TECHNICAL SERVICES ADVISORY MEMO

TO: Distribution
FROM: Technical Services
DATE: March 15, 2018
SUBJECT: NIC Panel Screw Attachment

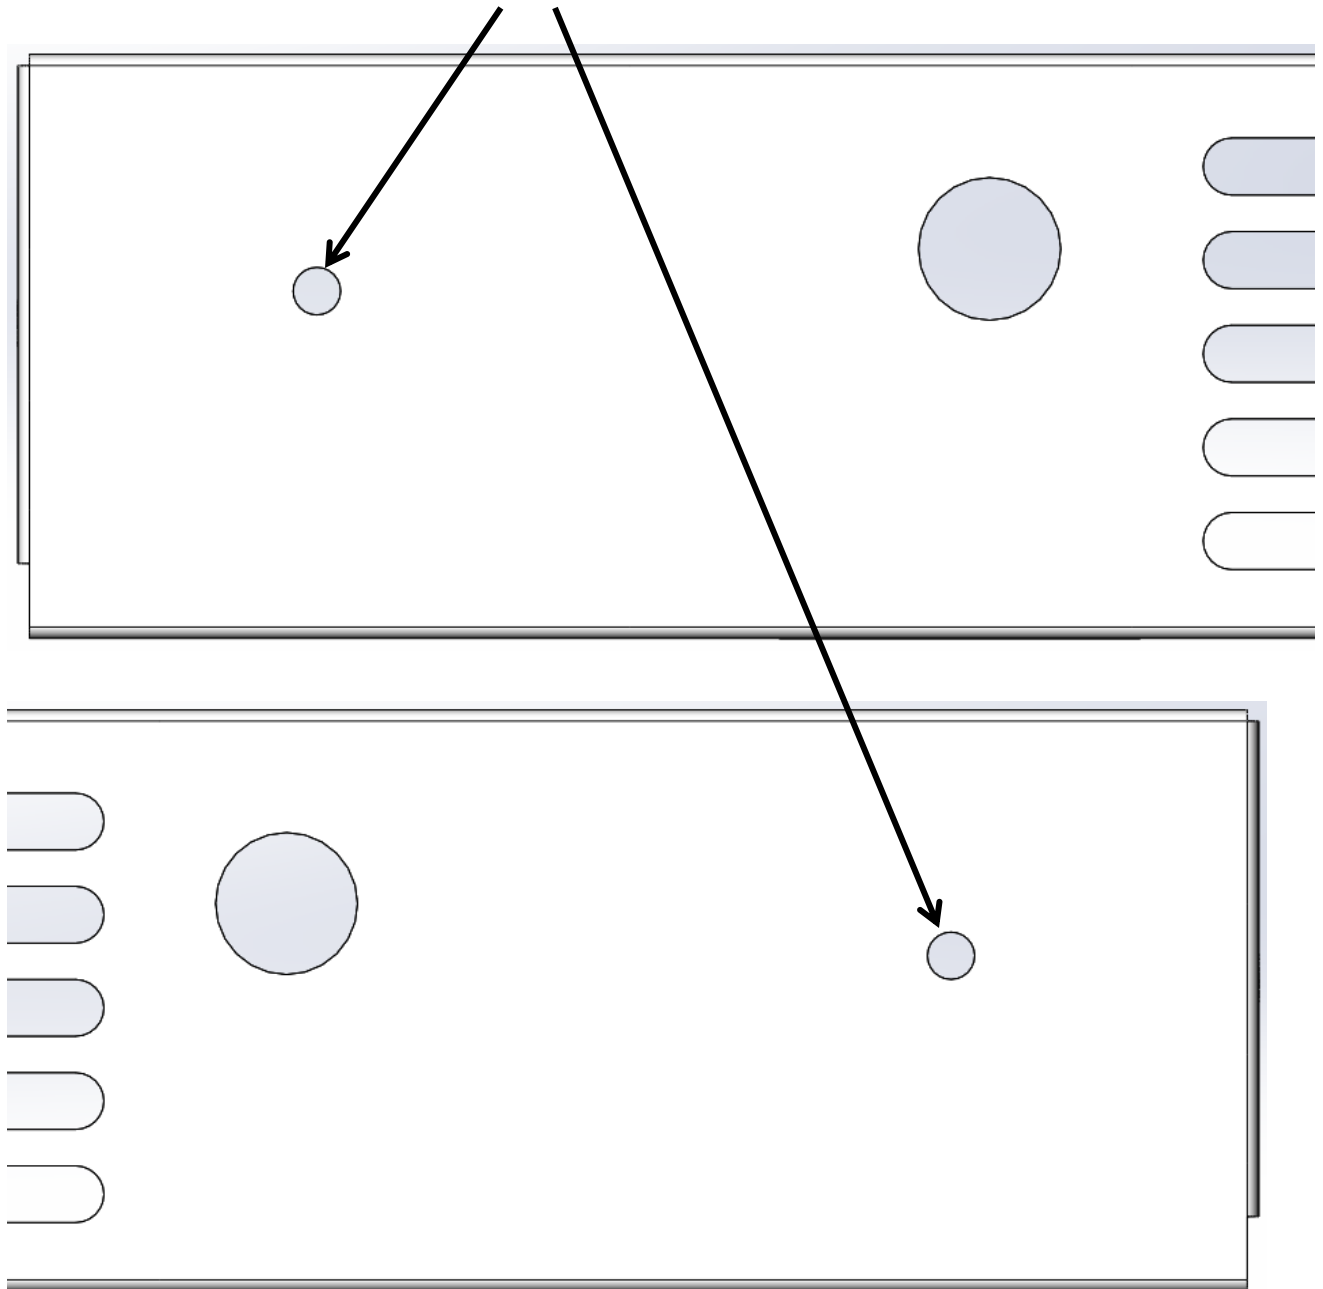
Lower NIC183S01 panel magnets may not hold the panel in place. To remedy:

Step 3: Drill two ¼ inch diameter holes in locations shown. The images below are full size when printed, so the location can be marked using this page.

Step 1: Obtain two #8 sheetmetal screws at least ¼ inch long, with pointed tips. Stainless steel, Phillips truss or pan head would have better appearance, but not required.

Step 4: Reinstall panel and install screws in holes that were added to panel.
